County Plan No.: SP-138-99
Project Name: WISE RECYCLING (HANKINS INDUSTRIAL PARK)
Stormwater Management Facility: WET POND

Project: WISE RECYCLING (HANKIN'S INDUSTRIAL PARK)
 BMP Facility: WET POND
 Plan No. SP-138-99
 BMP ID Code: WC 044

Re: Wise Recycling (Hankins Industrial Park)
County Plan SP-138-99; County BMP ID Code: WC 044
Stormwater Management Facility - Wet Pond

**RECORD DRAWING BASED ON FIELD SURVEY
 PERFORMED BY AES CONSULTING ENGINEERS**

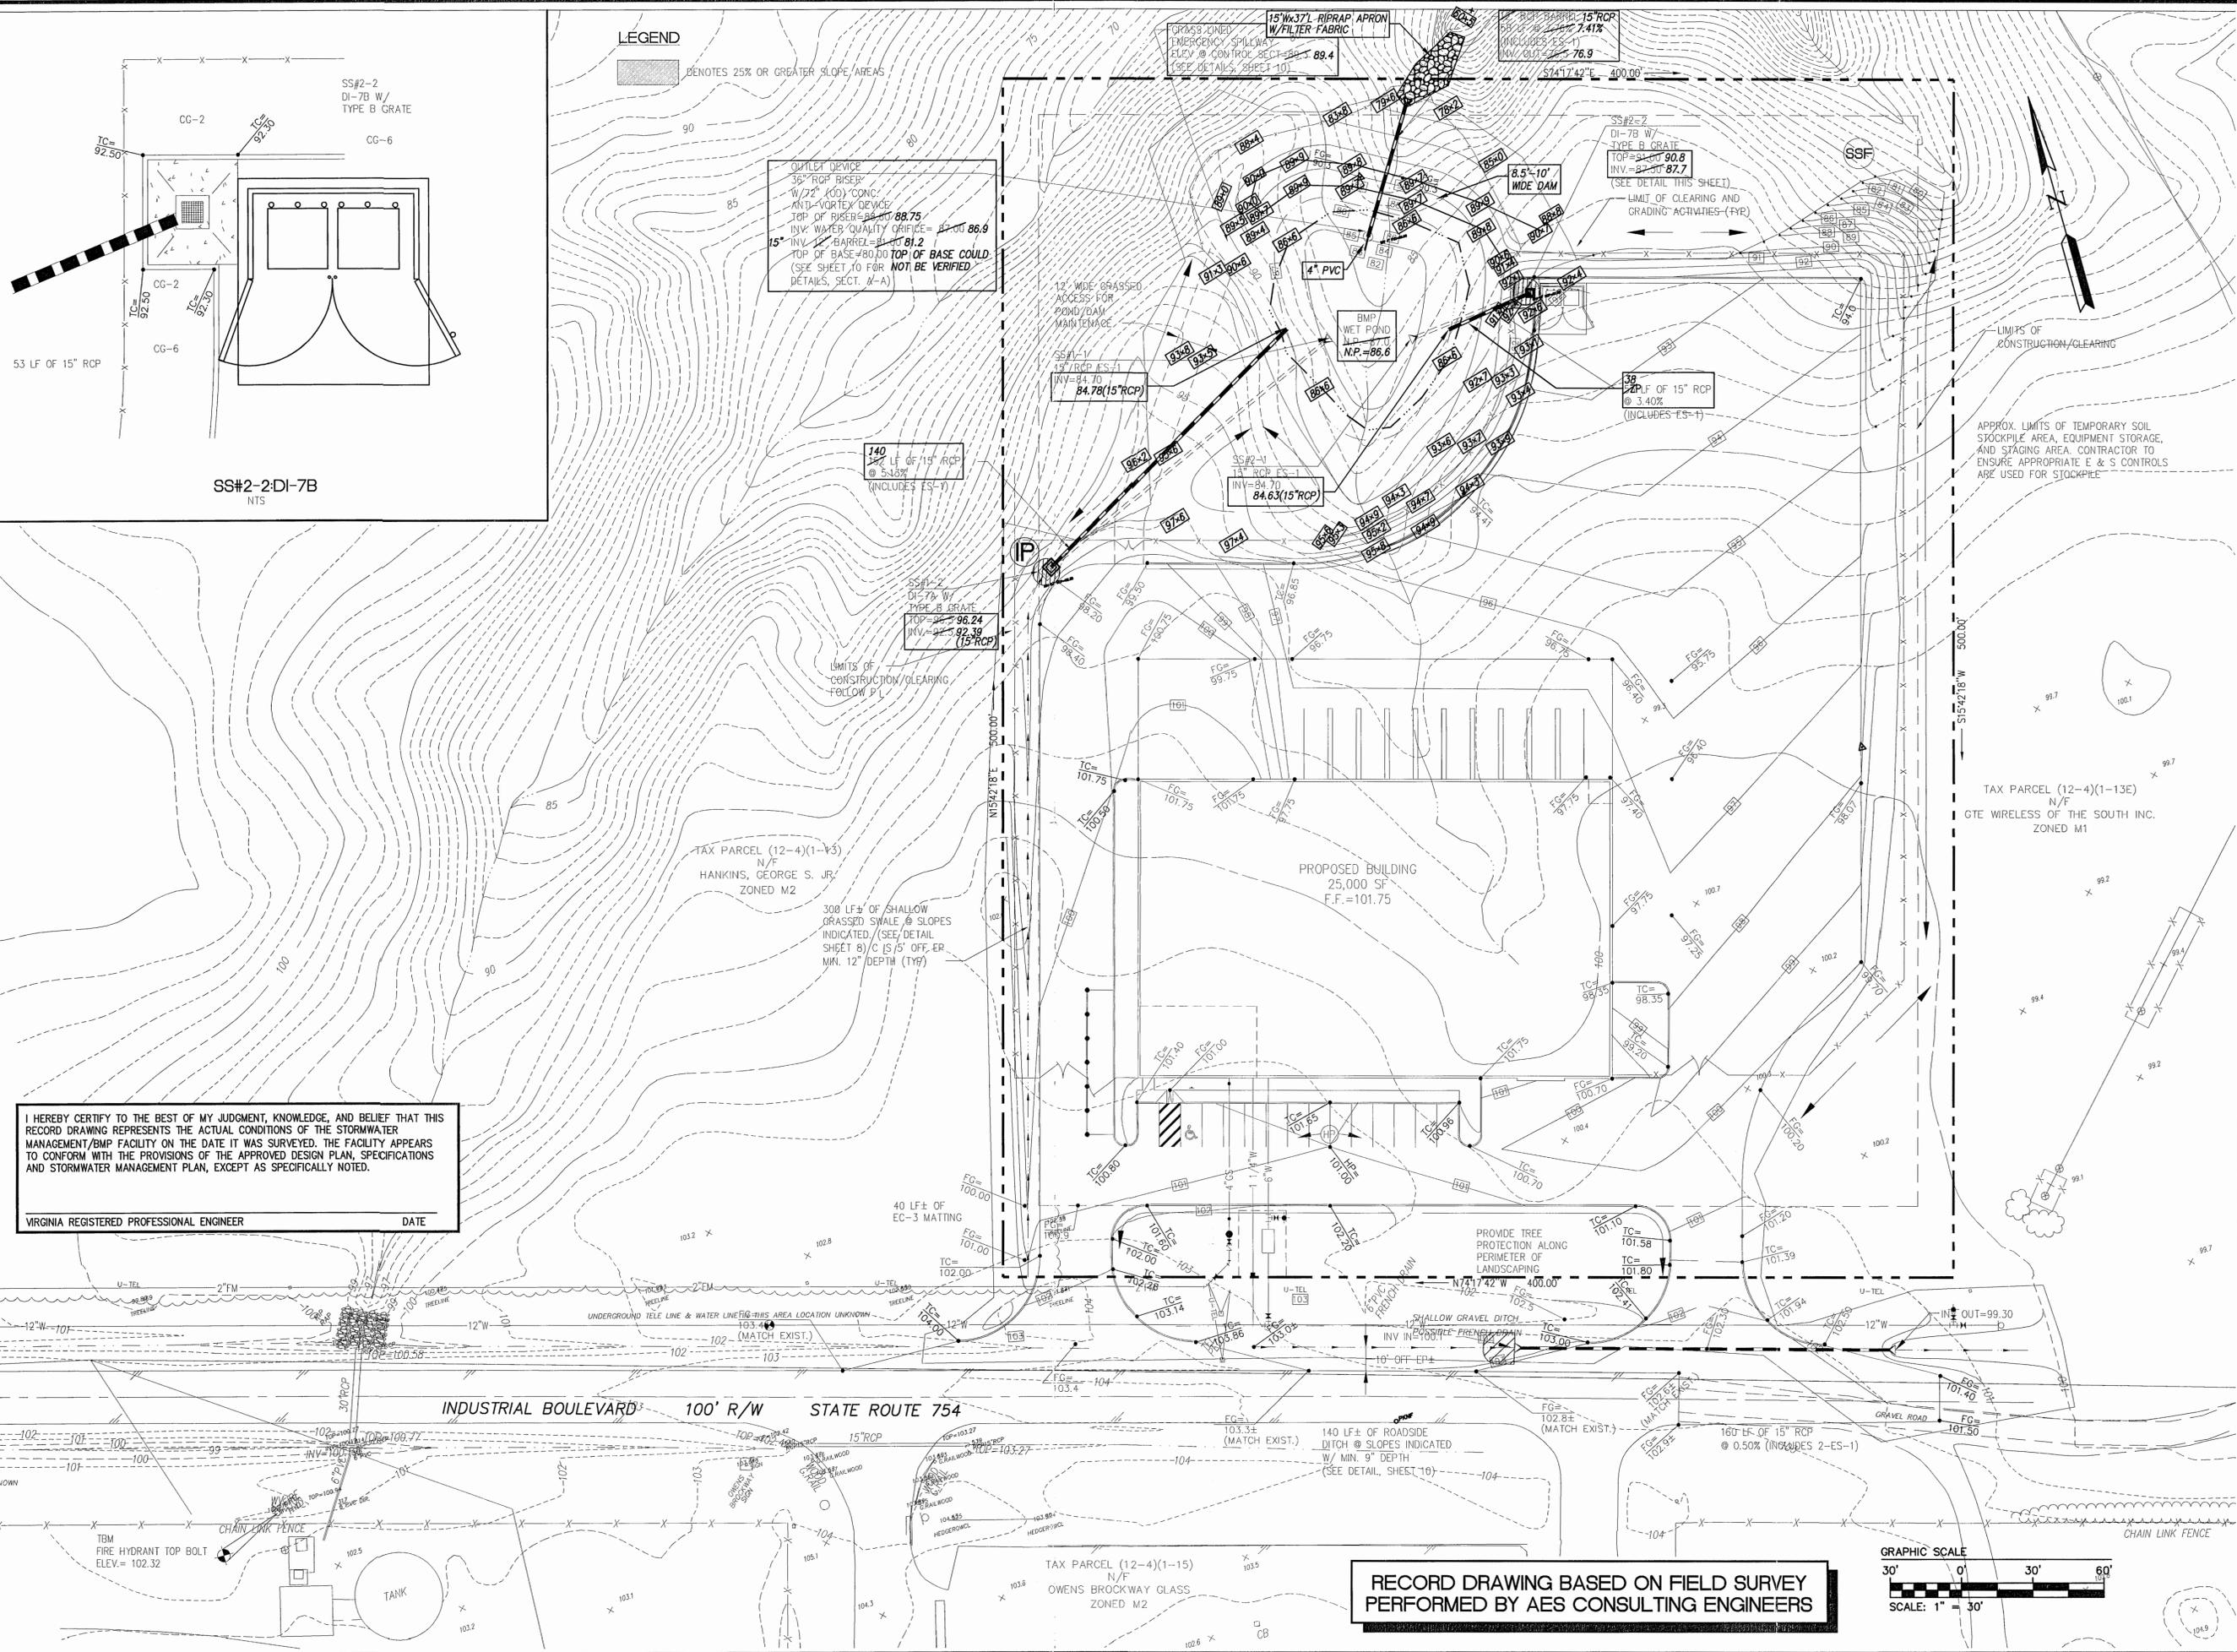
- 3. The record drawing set (two sheets) dated May 25 2001 is **satisfactory**, pending any changes that may occur as a result of construction-related (field) items as outlined below.

- 4. The approved plan called for a design top of dam elevation at El. 90.30 and a 12-inch diameter RCP outlet barrel through the dam. Based on a review of the as-built drawings, the actual low point along top of dam as constructed is at El. 89.7 and a 15-inch diameter RCP outlet barrel was used through the dam. The 100-year design high water elevation for the BMP was previously established at El. 88.99, therefore, freeboard to top of dam is at 0.71 feet. This does not conform with the provisions of the approved plan, which called for freeboard of 1.3 feet, nor the County's minimum standard of 1 foot for facilities with emergency spillways. Use of a 15-inch barrel, instead of a 12-inch barrel may result in an decrease in the design high water elevation and adequate freeboard may be present; however, it would still be unclear if use of a larger

barrel would result in the facility exceeding allowable discharges established for the facility for the 2-year design storm event. Use of a larger barrel size would result in higher discharge from the facility under routed hydraulic conditions. Therefore, either field correct the opening size of the outlet barrel through the dam to an appropriate 12-inch size; or alternatively, provide evaluation by an engineer that use of the 15-inch size barrel, as constructed, does not result in exceeding the allowable 2-year predevelopment discharge set for the facility and adequate freeboard from new 100-year design high water to top of dam elevation (El. 89.7) as constructed is present. (Note: A hydraulic model of the pond to show adequacy should be based on field obtained as-built conditions).

GRADING, DRAINAGE, AND EROSION AND
SEDIMENT CONTROL PLAN

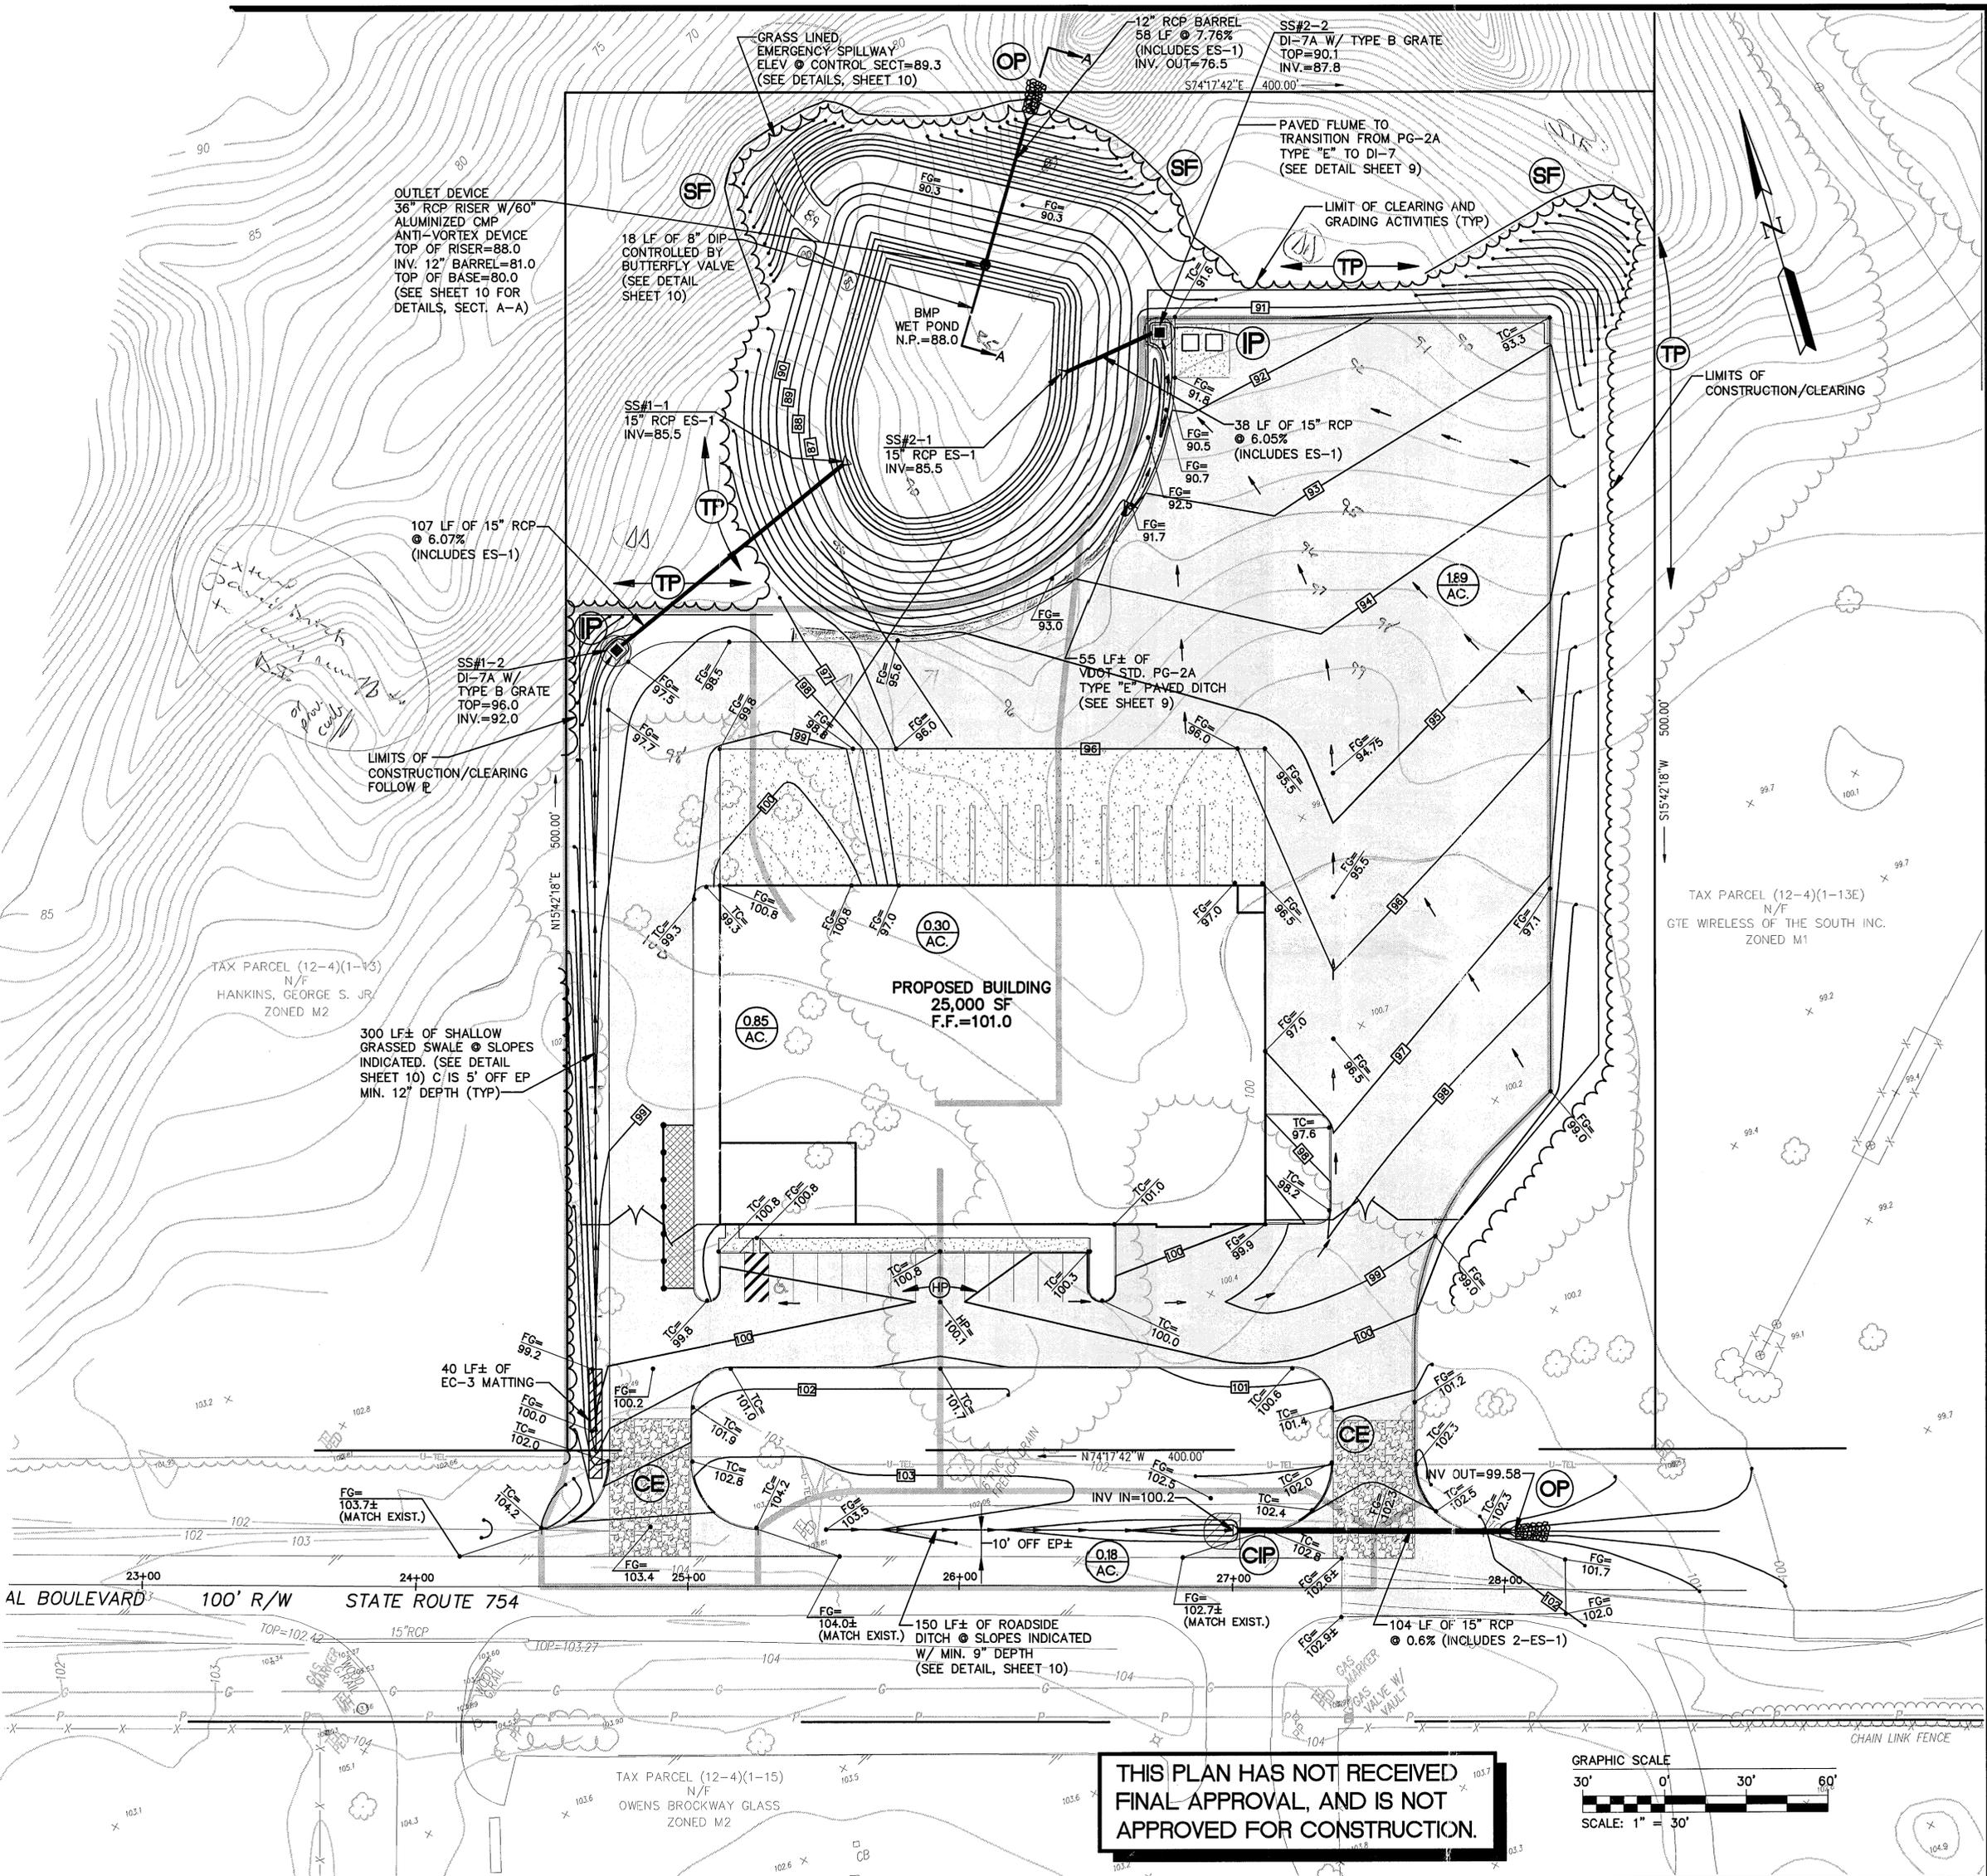
During revision of the 100 year elevation and anti-seep collars, we reviewed the design of the reverse slope pipe supports and decided to modify the design in order to provide greater stability. The modification includes shortening the pipe from 17' to 8.5', eliminating one of the wooden support structures, and, most importantly, providing a more substantial concrete footing for the remaining support structure. We believe this modification will provide greater stability for the 4" pipe and will reduce any chance of support failure.
